**NEW YORK STATE THRUWAY AUTHORITY
DEPARTMENT OF ENGINEERING**

**AMENDMENT NO. 5
TO**

**CONTRACT TANY 26-17B
D215020
REPLACEMENT OF THE PINE HILL ROAD
BRIDGE OVER I-87 AT MP 47.58,
REHABILITATION OF I-87 BRIDGE OVER
SMITH CLOVE ROAD AT MP 47.04,
AND RESURFACING AND SAFETY IMPROVEMENTS
ON I-87 BETWEEN MP 46 AND MP 48
IN THE NEW YORK DIVISION
OF THE NEW YORK STATE THRUWAY
IN ORANGE COUNTY**

**IN THE LETTING OF
JUNE 24, 2026**

TITLE OF PROJECT	I-87 BRIDGE REHABILITATION OVER SMITH CLOVE ROAD (MP 47.04)	CONTRACT NUMBER:	TANY 26-17B
LOCATION OF PROJECT	VILLAGE OF WOODBURY ORANGE COUNTY BIN 5514279	DATE:	05/21/2025
TITLE OF DRAWING	I-87 WORK ZONE TRAFFIC CONTROL PLAN STAGE 1 (6 OF 7)	DRAWING NUMBER:	WZTC-1-06

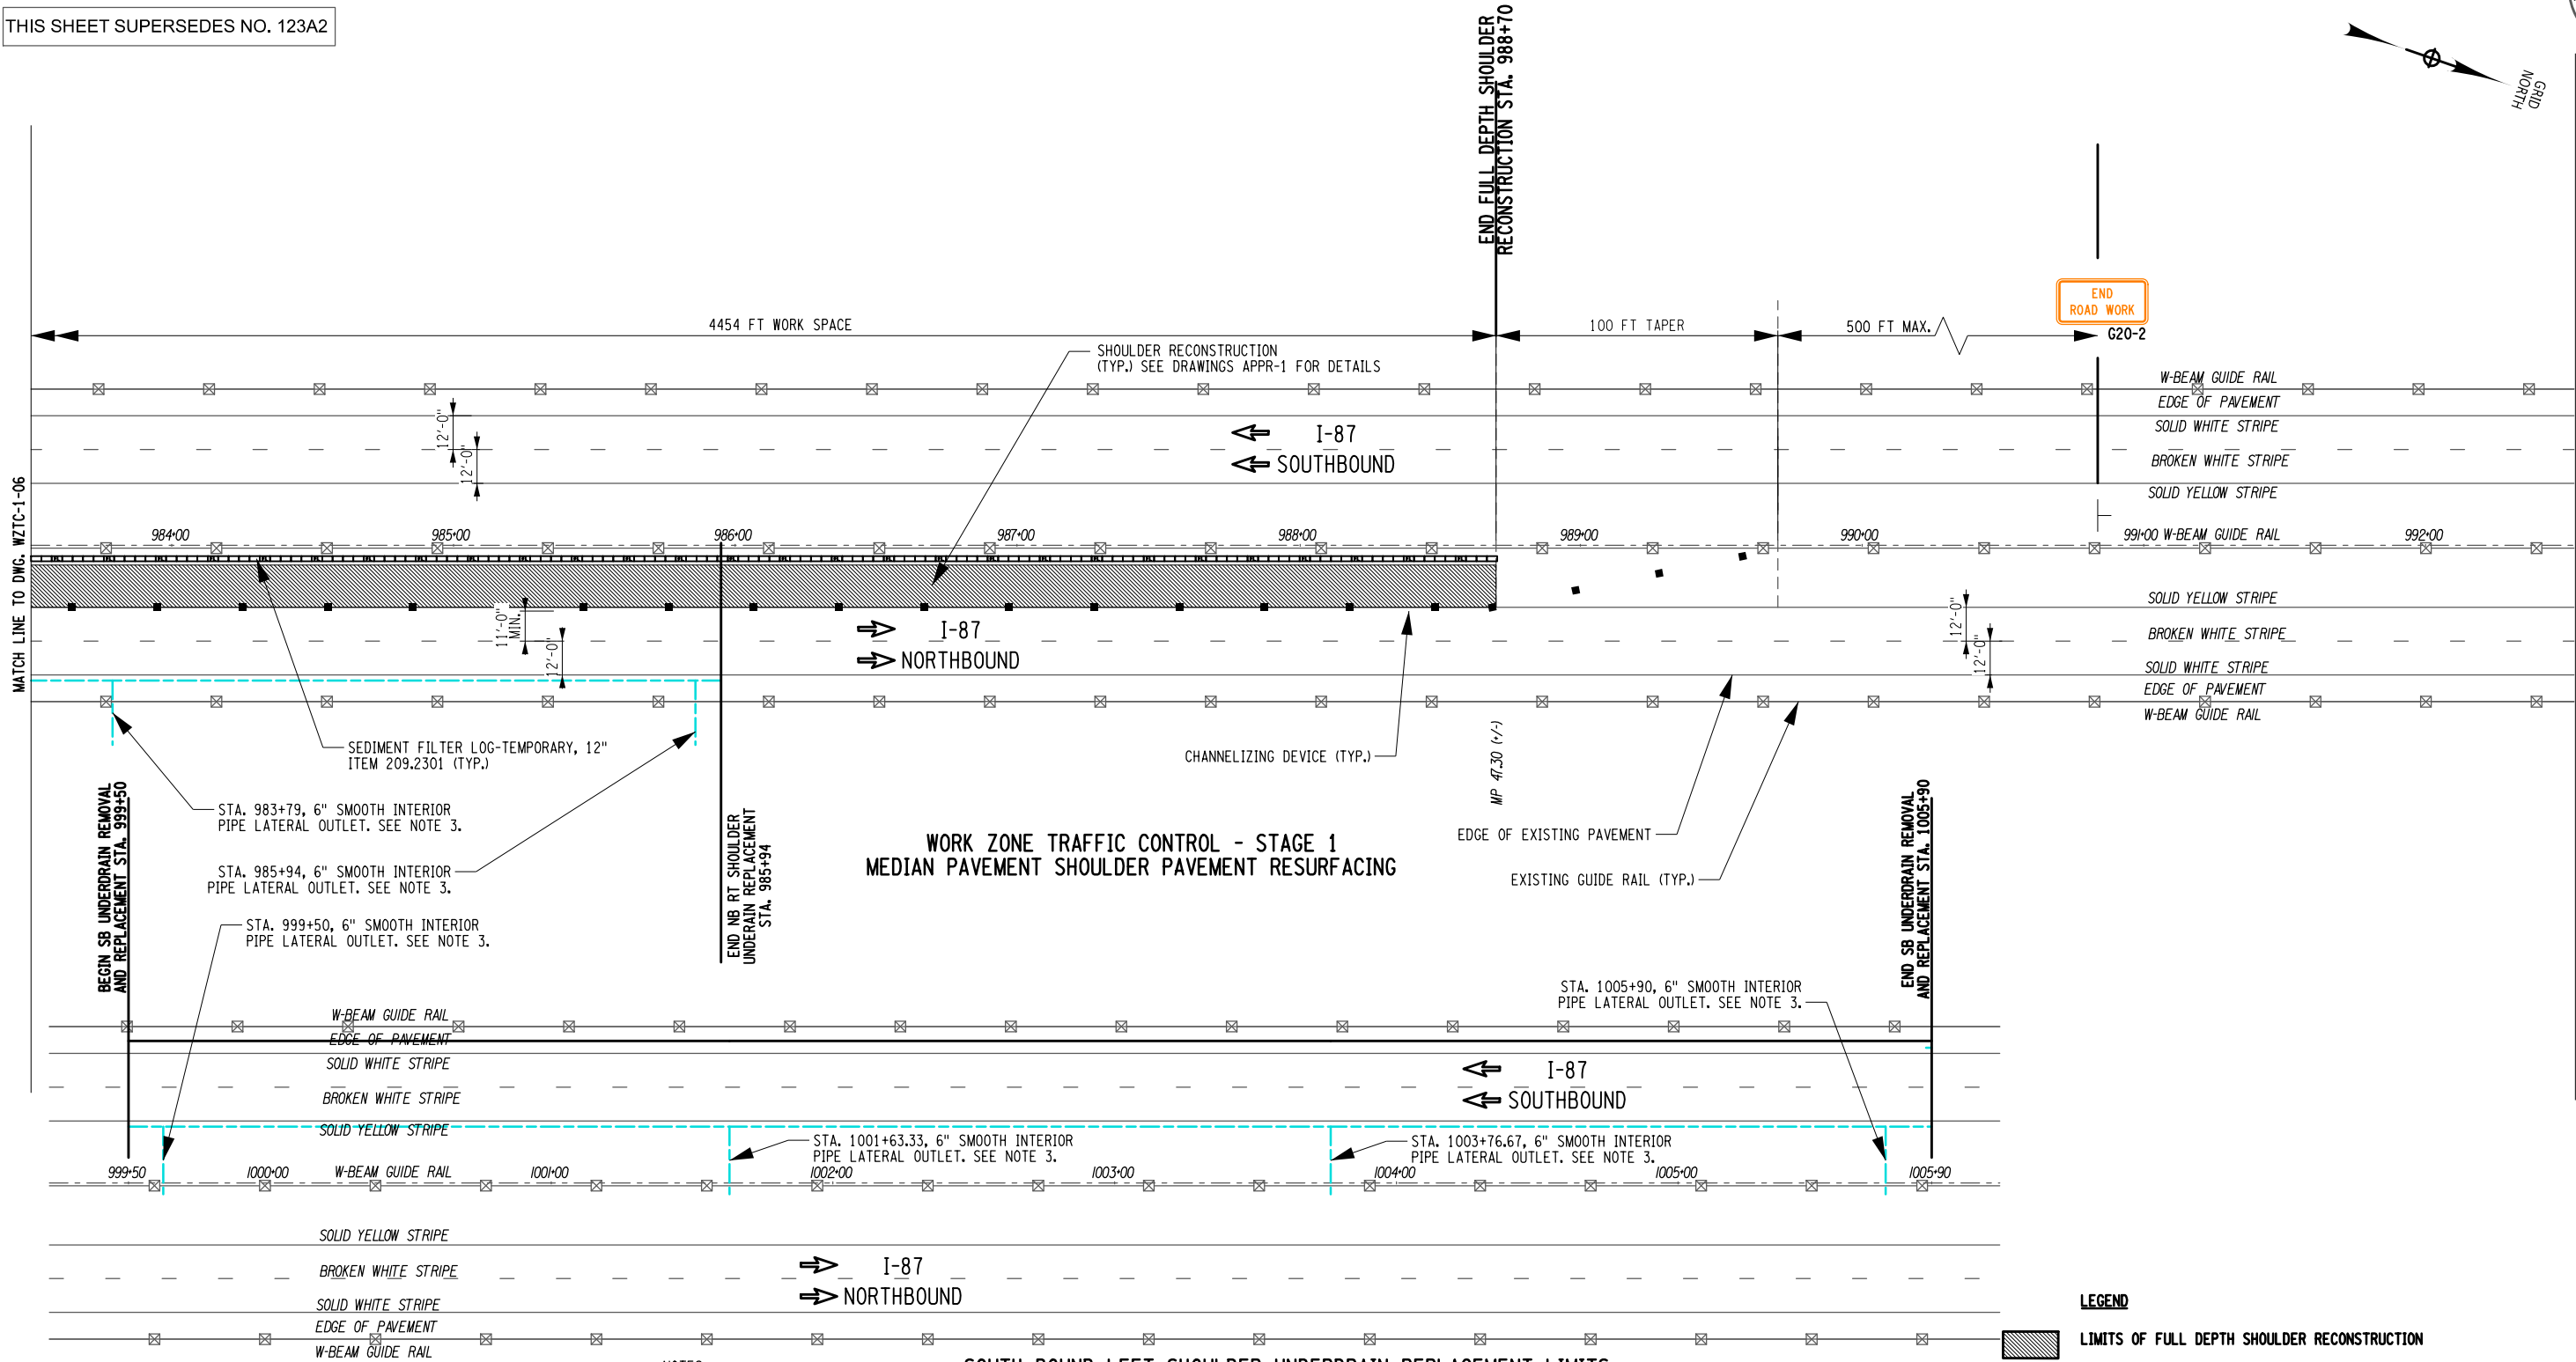
13. **DELETE** Drawing Number WZTC-1-06, Sheet 122A2 of 180, and **SUBSTITUTE** with the attached Drawing Number WZTC-1-06, Sheet 122A5 of 180. A printing error affecting line styles for Temporary Concrete Barrier, channelizers, and sediment filter logs have been corrected. In the Legend and as called out near Station 977+00 (middle left), the prospective bidder is to revise any previous reference in the drawing for Item 209.2301, Sediment Filter Log Temporary, 12" to read as Item 209.1311, Sediment Filter Log - Temporary, 12", Type A, instead.

DRAWING NUMBER:
WZTC-1-07

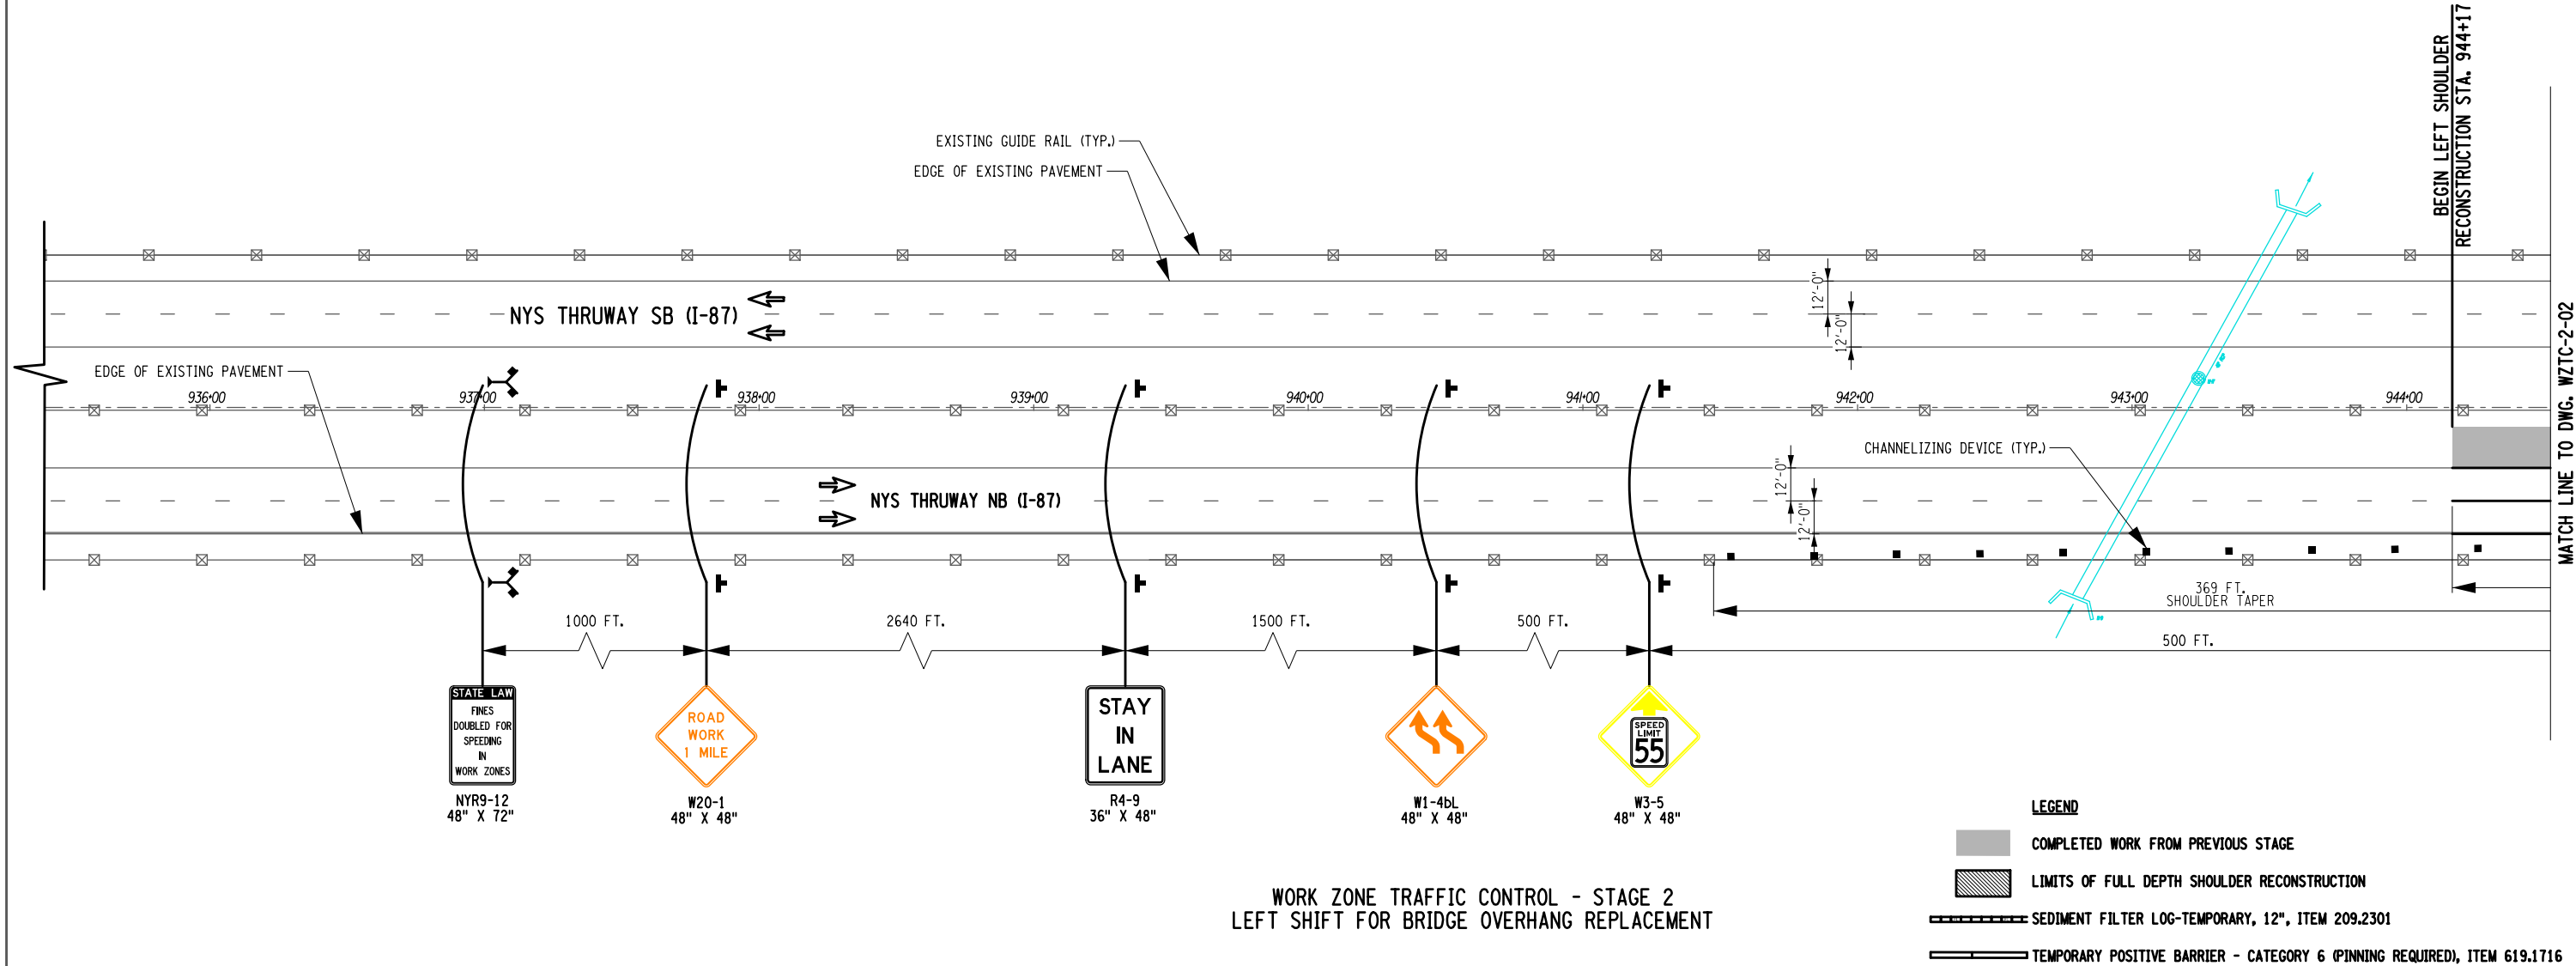
14. **DELETE** Drawing Number WZTC-1-07, Sheet 123A2 of 180, and **SUBSTITUTE** with the attached Drawing Number WZTC-1-07, Sheet 123A5 of 180. A printing error affecting line styles for Temporary Concrete Barrier, channelizers, and sediment filter logs have been corrected. In the Legend and as called out near Station 984+00 (bottom left), the prospective bidder is to revise any previous reference in the drawing for Item 209.2301, Sediment Filter Log Temporary, 12" to read as Item 209.1311, Sediment Filter Log - Temporary, 12", Type A, instead.

TITLE OF PROJECT I-87 BRIDGE REHABILITATION OVER SMITH CLOVE ROAD (MP 47.04)	CONTRACT NUMBER: TANY 26-17B
LOCATION OF PROJECT VILLAGE OF WOODBURY ORANGE COUNTY BIN 5514279	DATE: 05/21/2025
TITLE OF DRAWING WORK ZONE TRAFFIC CONTROL STAGE 2 PLAN (1 OF 6)	DRAWING NUMBER: WZTC-2-01

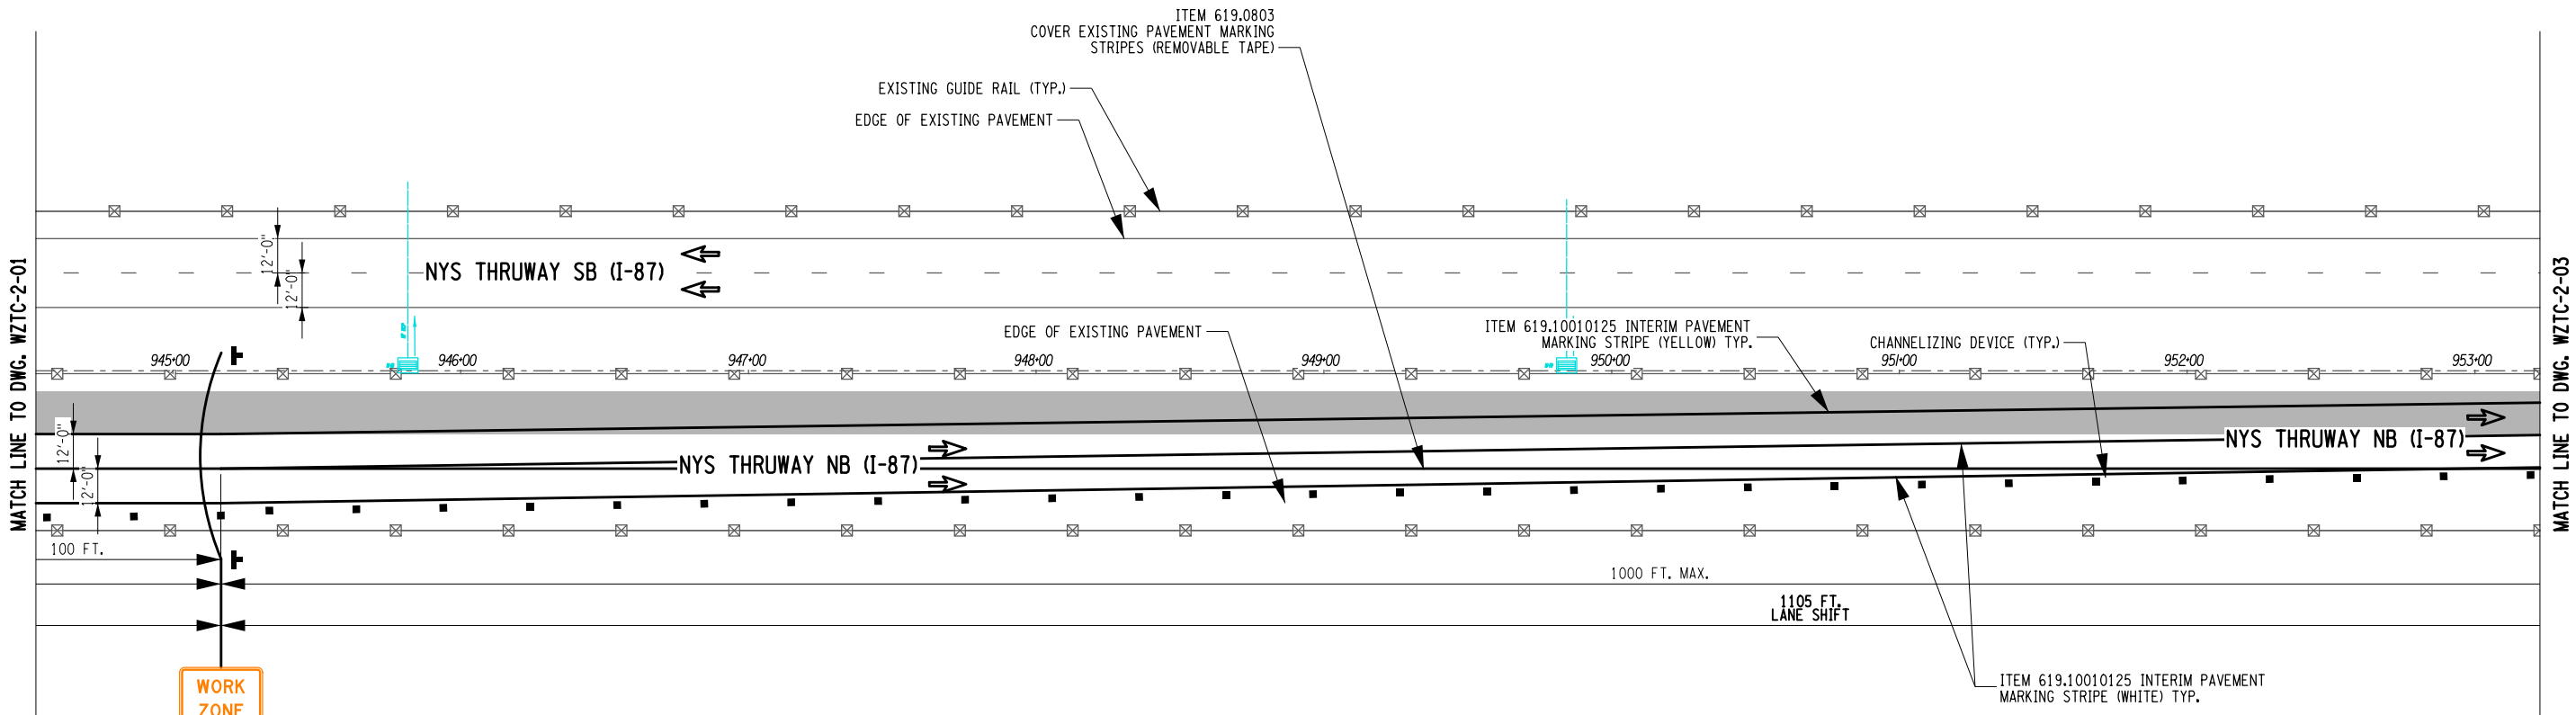
15. **DELETE** Drawing Number WZTC-2-01, Sheet 124 of 180, and **SUBSTITUTE** with the attached Drawing Number WZTC-2-01, Sheet 124A5 of 180. A printing error affecting line styles for Temporary Concrete Barrier, channelizers, and sediment filter logs have been corrected. In the Legend the prospective bidder is to revise any previous reference in the drawing for Item 209.2301, Sediment Filter Log Temporary, 12" to read as Item 209.1311, Sediment Filter Log - Temporary, 12", Type A, instead.

TITLE OF PROJECT: I-87 BRIDGE REHABILITATION OVER SMITH CLOVE ROAD (MP 47.04)	CONTRACT NUMBER: TANY 26-17B
LOCATION OF PROJECT: VILLAGE OF WOODBURY ORANGE COUNTY BIN 5514279	DATE: 05/21/2025
TITLE OF DRAWING: WORK ZONE TRAFFIC CONTROL STAGE 2 PLAN (3 OF 6)	DRAWING NUMBER: WZTC-2-03

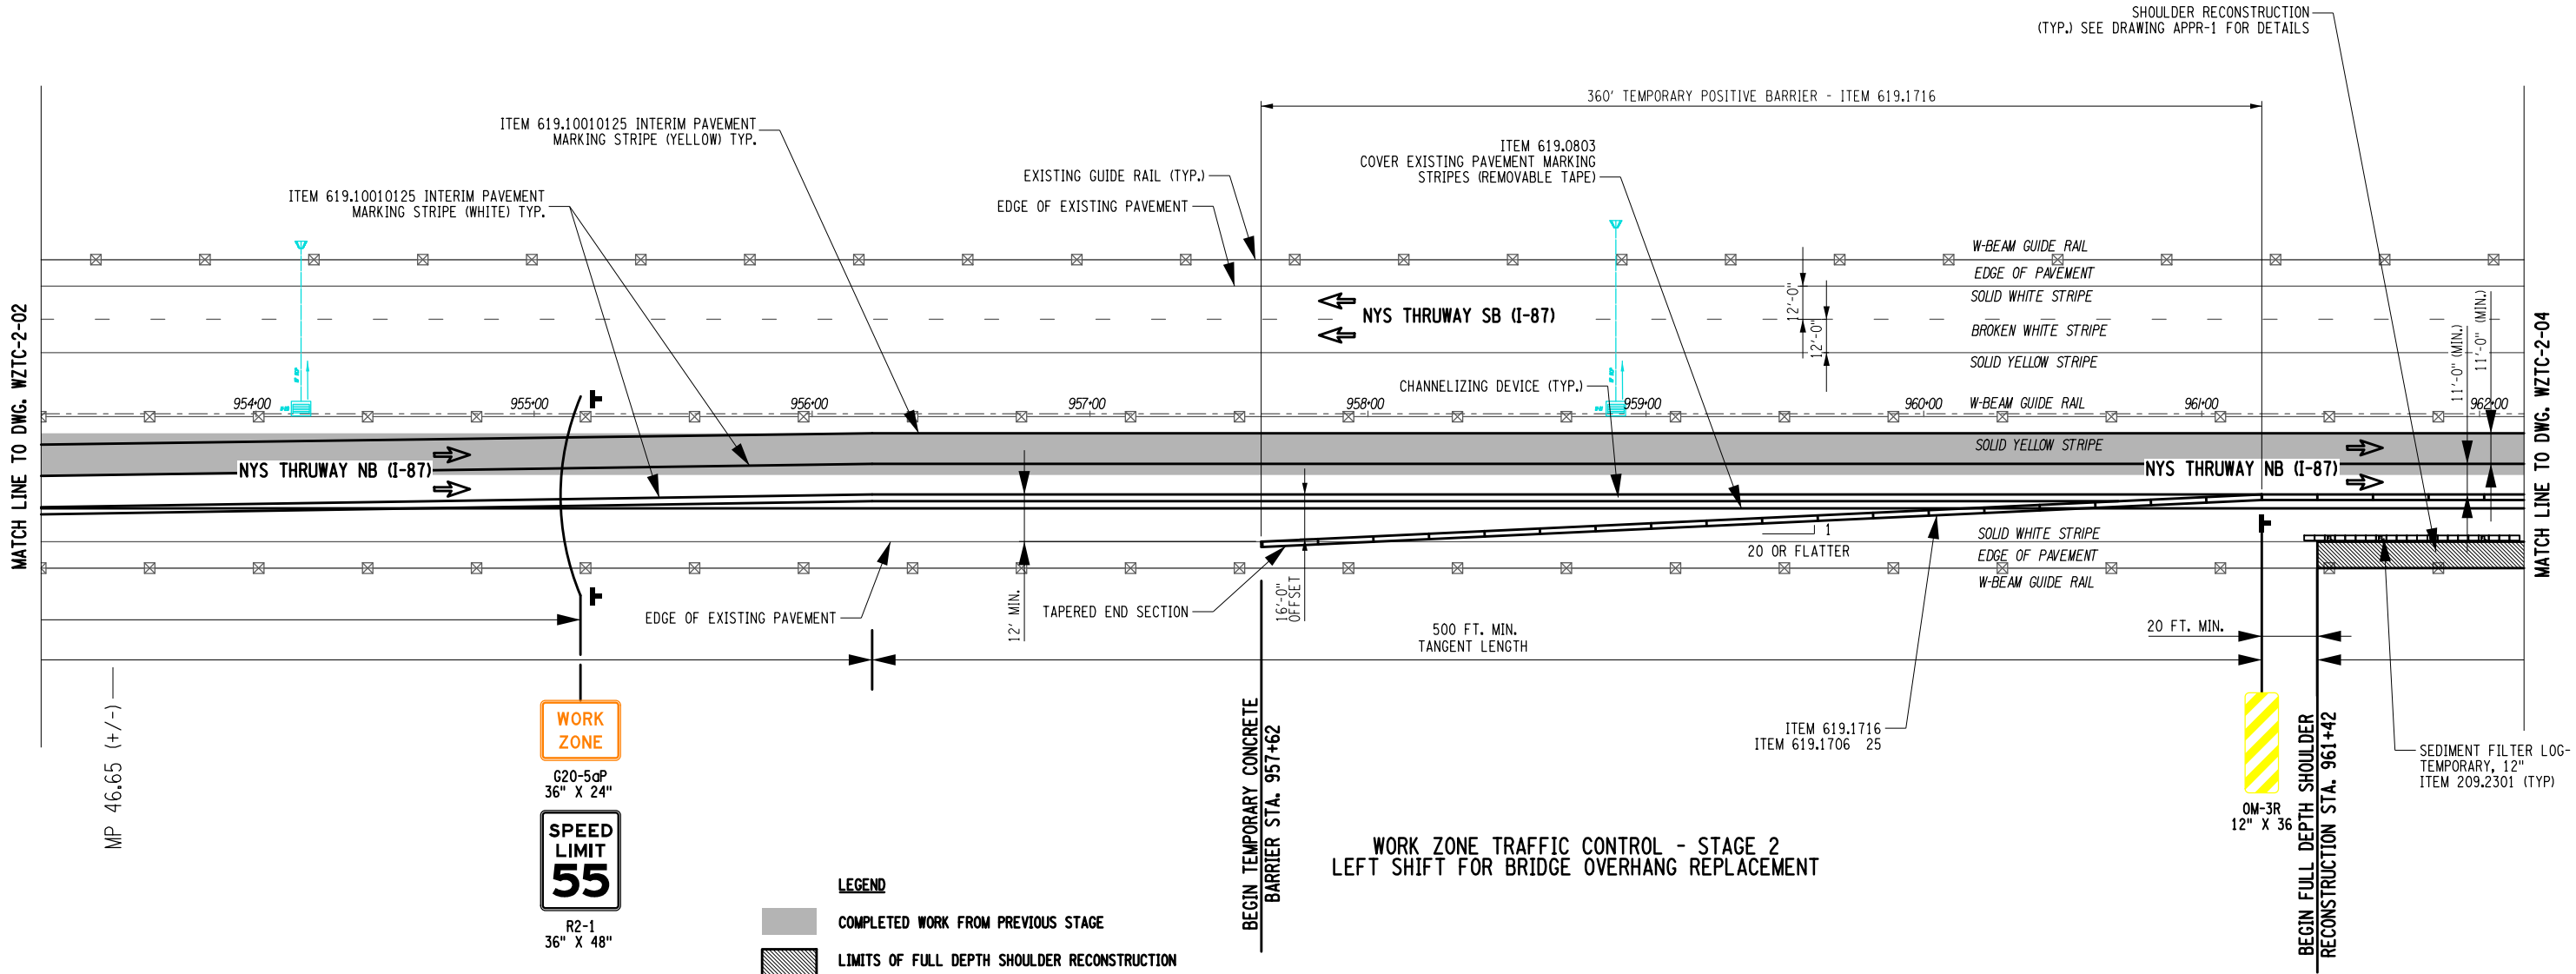
17. **DELETE** Drawing Number WZTC-2-03, Sheet 126 of 180, and **SUBSTITUTE** with the attached Drawing Number WZTC-2-03, Sheet 126A5 of 180. A printing error affecting line styles for Temporary Concrete Barrier, channelizers, and sediment filter logs have been corrected. In the Legend and as called out near Station 962+00 (bottom right), the prospective bidder is to revise any previous reference in the drawing for Item 209.2301, Sediment Filter Log Temporary, 12" to read as Item 209.1311, Sediment Filter Log - Temporary, 12", Type A, instead.
